SERVICE LETTER 233

Cessna 170 Hydraulic Pump Replacement on 2100A Floats

Aircraft Makes/Model(s):	Float Model(s):	Compliance: Optional	By: MAB
Textron Aviation 170A & 170B	2100A	Part Number: 1011890	Approved: SDW
		Date: 6/10/2021	Revision: A

**DISCONTINUED 12 VDC
HYDRAULIC PUMP 21A09000-279**

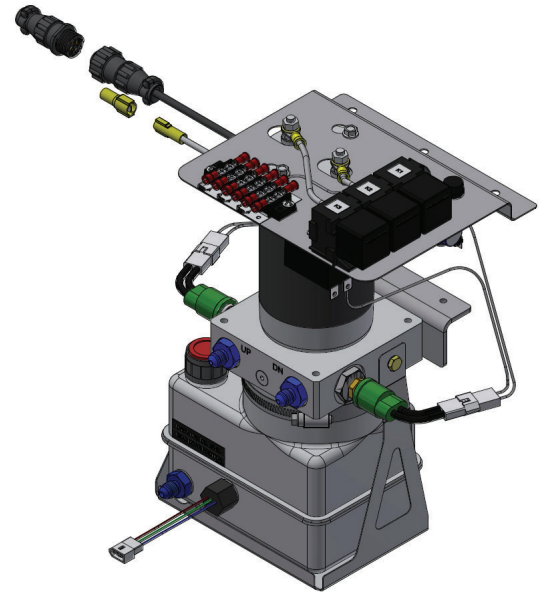
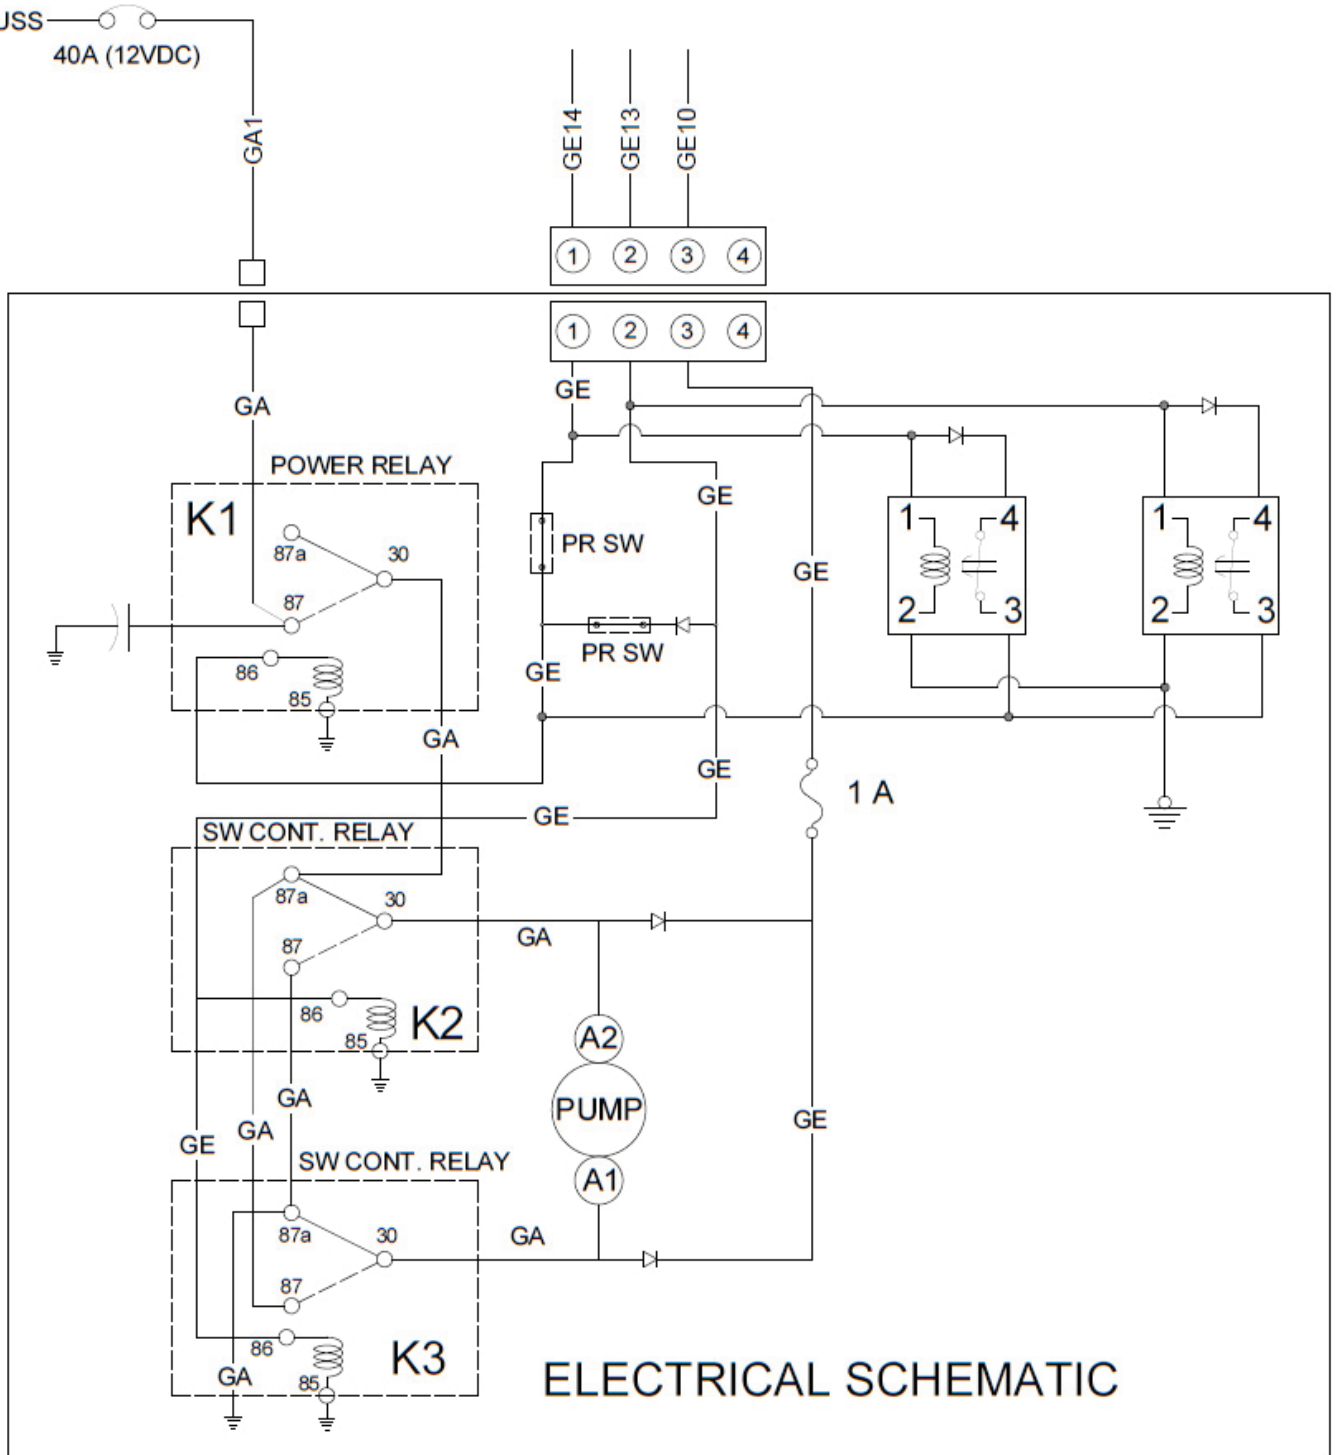
Textron Aviation (Cessna) 170A and 170B Hydraulic Pump Assembly 21A09000-279 has been discontinued. This service letter provides the option to replace it with pump 1011887.

8. Unbolt and remove hydraulic power pack 21A09000-279 from mounting assembly.
9. Install new hydraulic power pack 1011887 using supplied hardware.
10. Re-install hydraulic lines 21A09000-227 onto pump manifold up and dn ports.

13. Re-install 4 pin CPC connector. See electrical schematic.
14. Cut single pin Molex connector from GA1 wire. Install 73F-250-32NL connector onto GA1 wire. Connect GA1 wire to power wire on hydraulic power pack assembly. See electrical schematic.
